Burlington Development Review Board

BURLINGTON DEVELOPMENT REVIEW BOARD Wednesday March 2, 2016, 5:00 PM Contois Auditorium, City Hall, 149 Church Street, Burlington, VT Minutes

1. 16-0762PD; 16 Rose St (RM, Ward 3C) J & S LLC

To: Development Review Board
From: Mary O'Neil, AICP, Principal Planner
Date: March 2, 2016
RE: 56, 58 and 66 North Avenue

DRAWING NO.
A-3.0

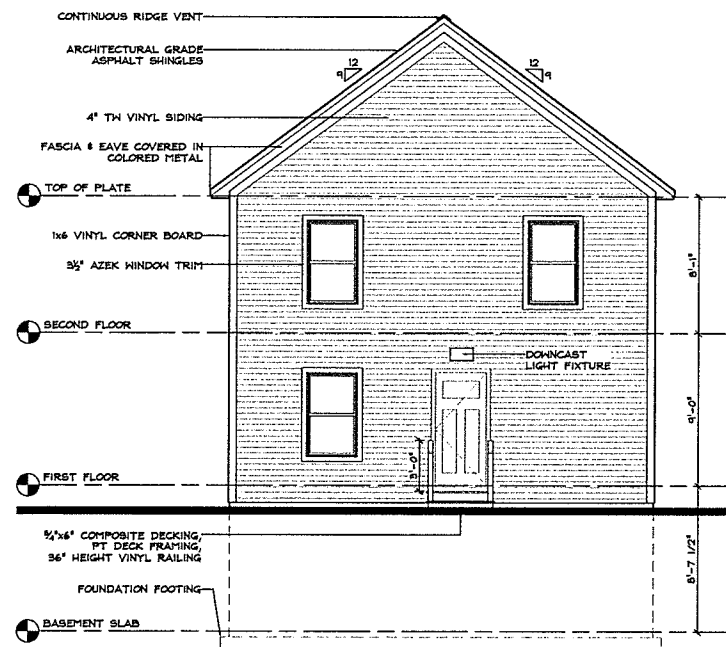
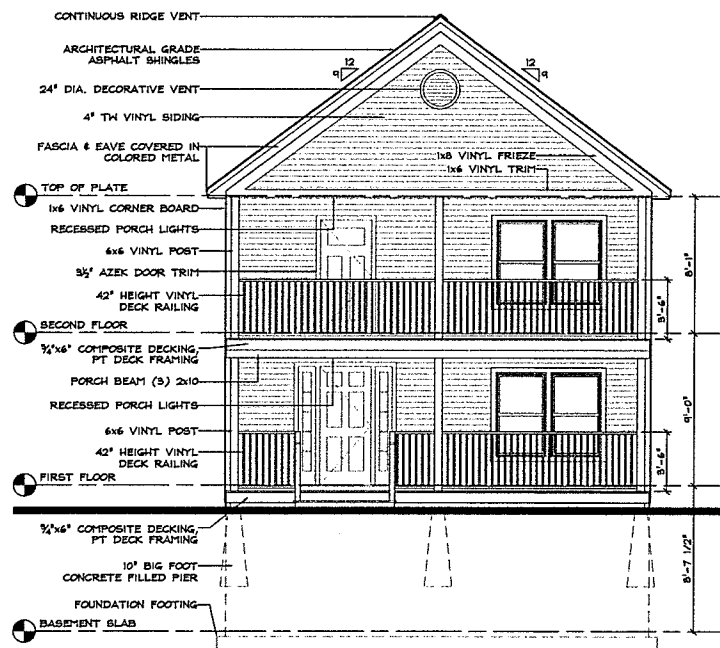
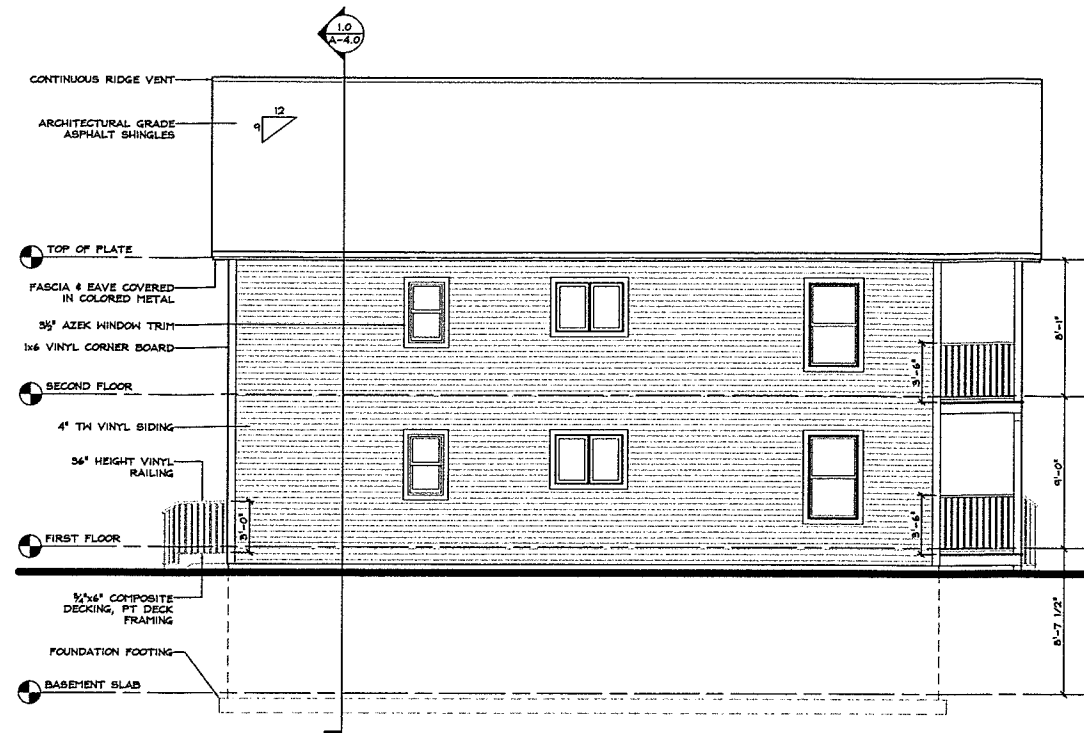
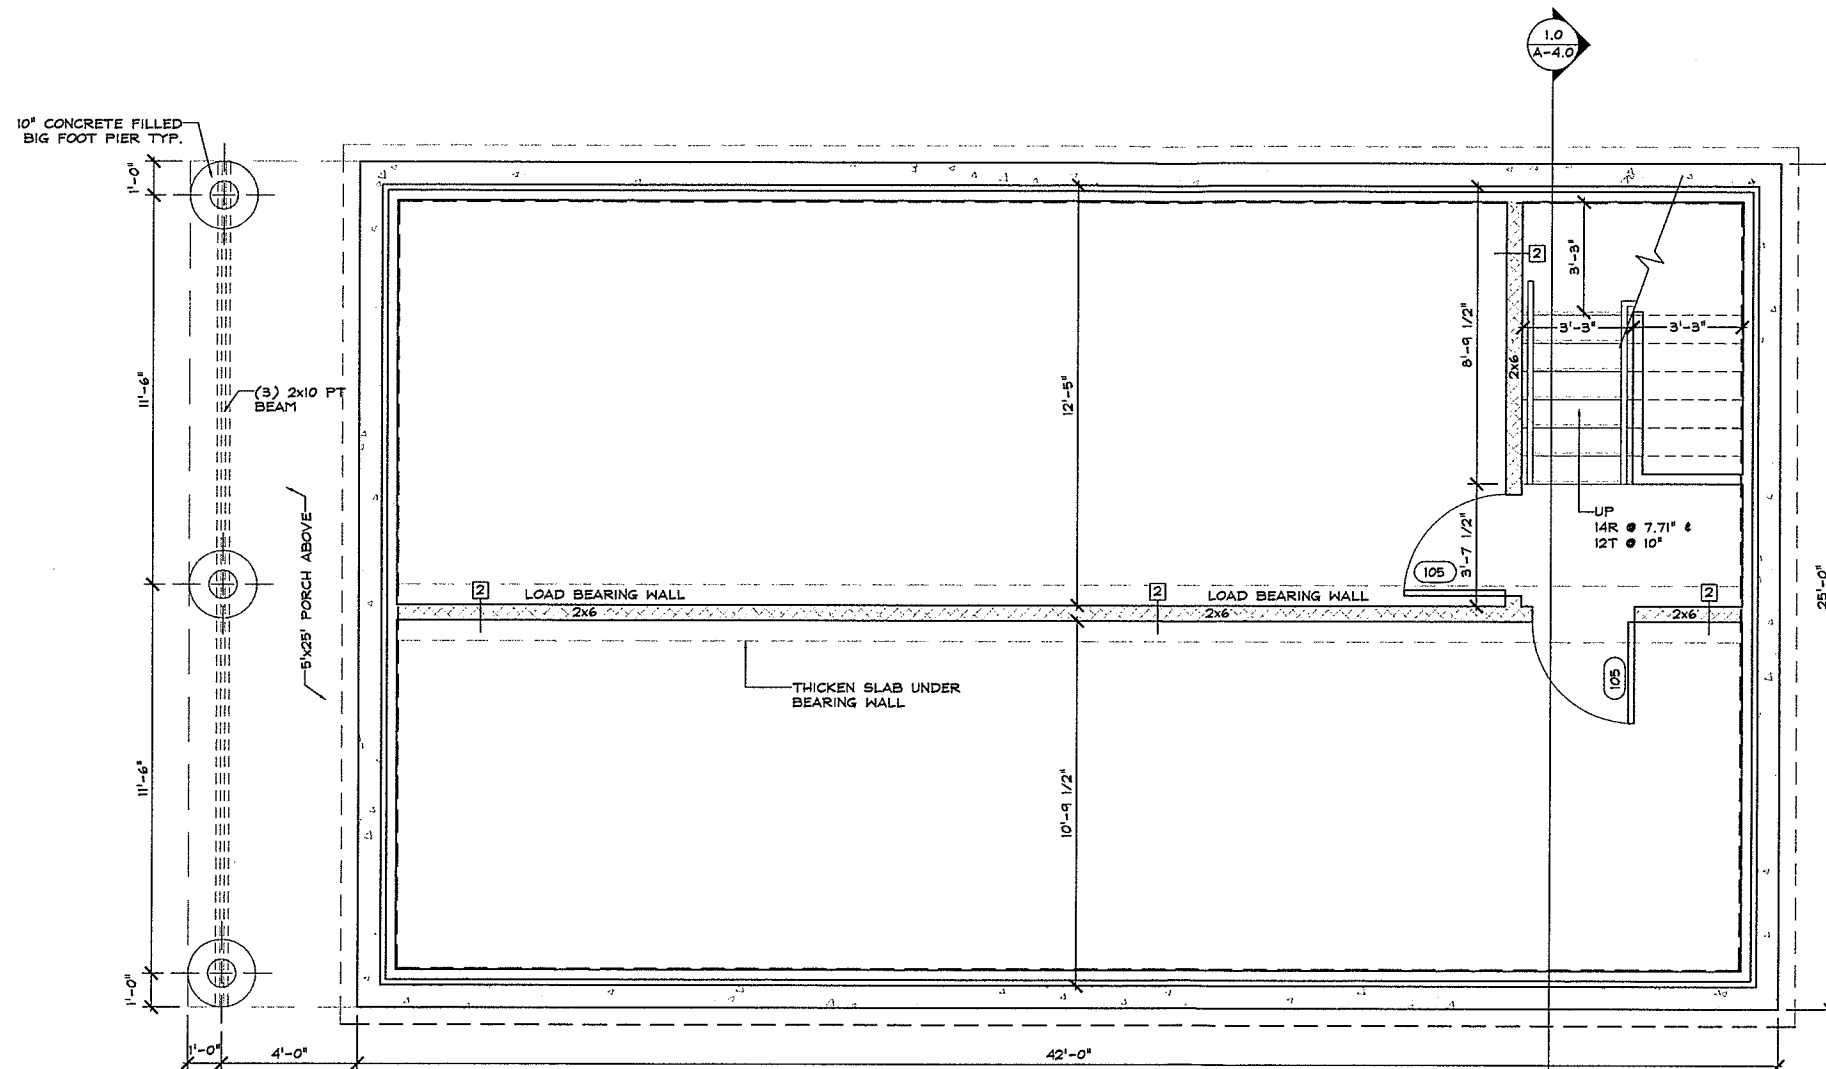
A.Hart – questioned presentation of front elevation on Rose St.

S.Giles - south side is limited with glass. Could add more windows on north side.

Window openings shall maintain consistent patterns and proportions appropriate to the use. The window pattern should add variety and interest to the architecture, and be proportioned to appear more vertical than horizontal. Where awnings over windows or doors are used, the lowest edge of the awning shall be at least eight (8) feet above any pedestrian way, and shall not encroach into the public right-of-way without an encroachment permit issued by the dept. of public works.

FIRST FLOOR PLAN
SCALE: 3/8" = 1'-0"

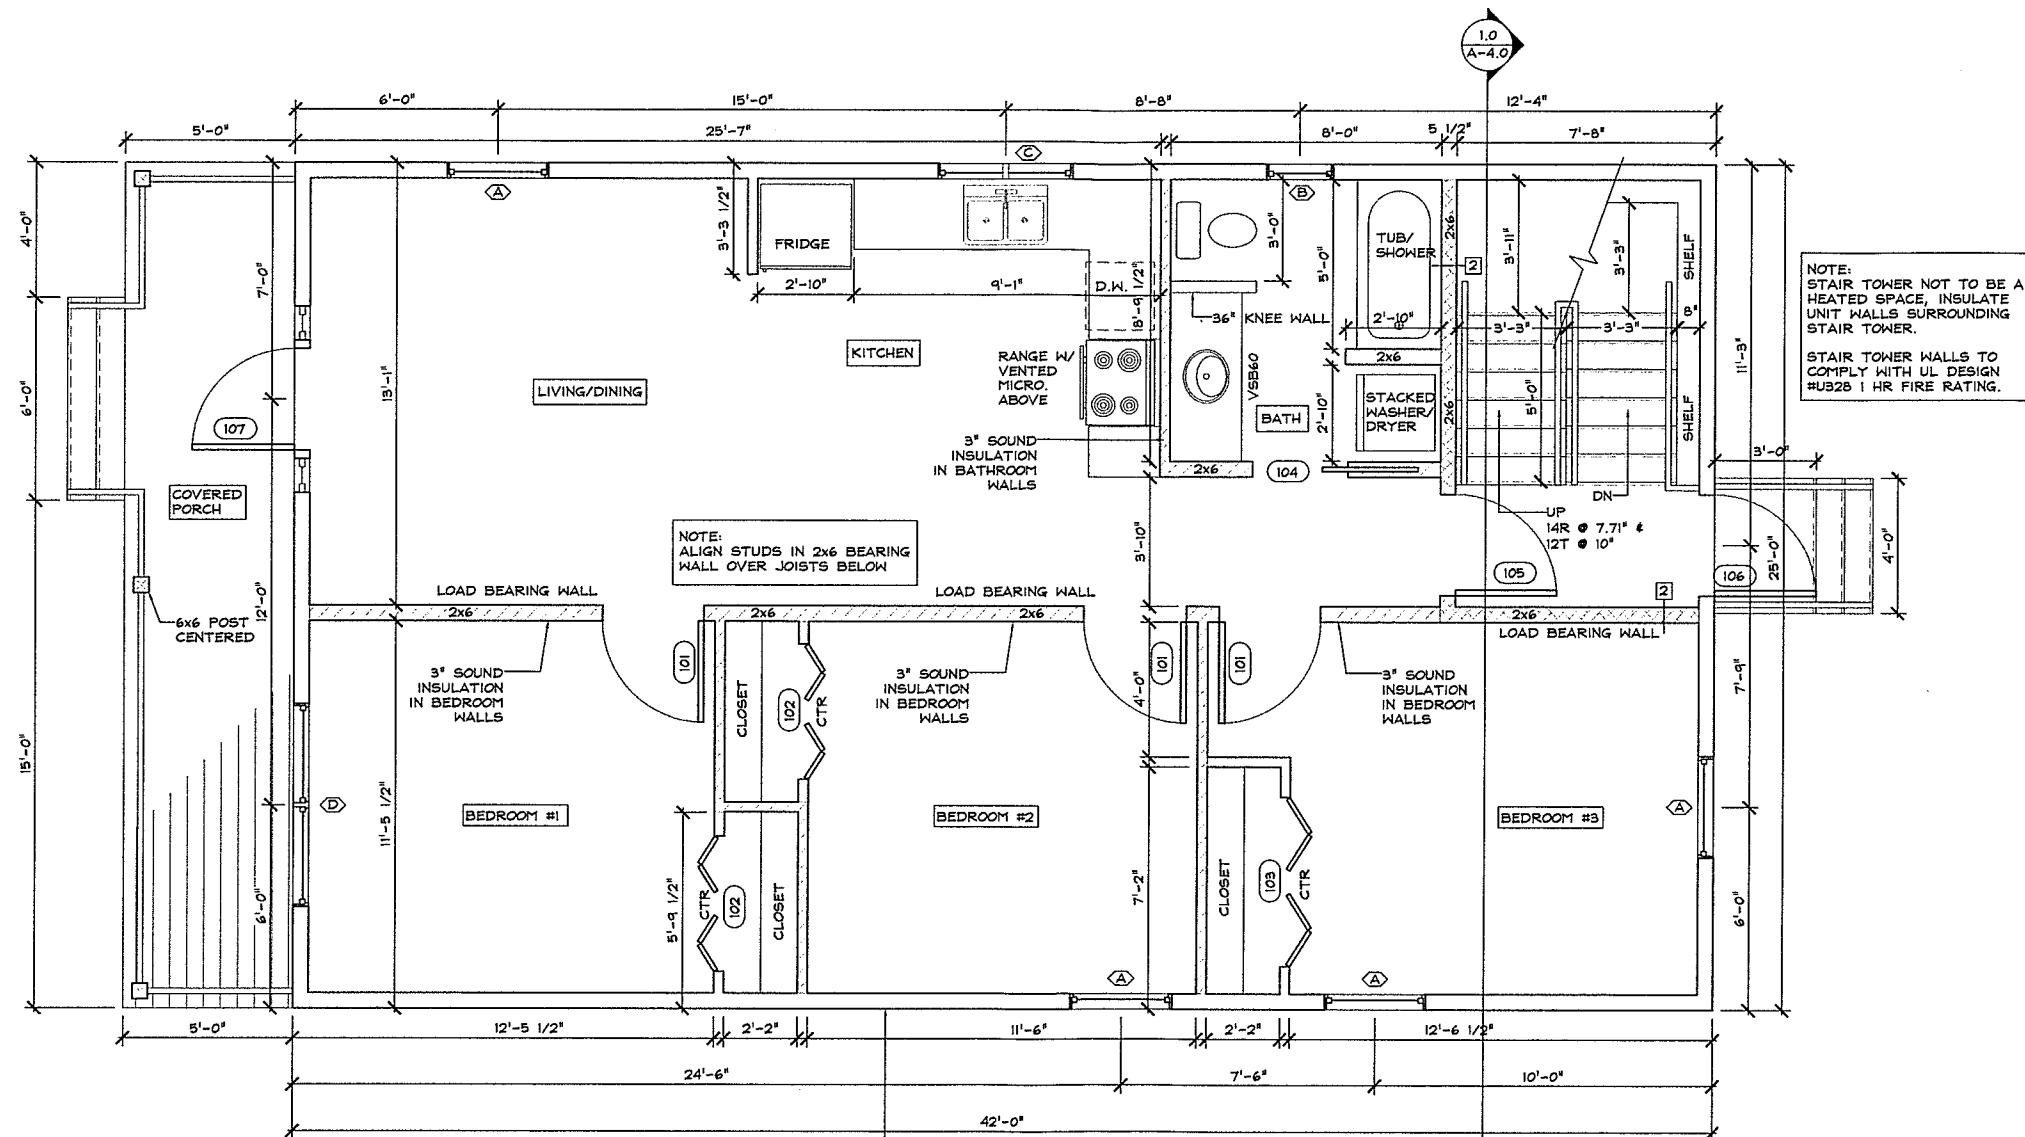
Notes on plans suggest that accessibility standards, effective as of April 2012 will be implemented for entry door widths and interior door passage. No provision is included in the plan to make at-grade entrances for the new units; however any requirement for ADA access is under the review of the building inspector. **Affirmative finding if conditioned.**
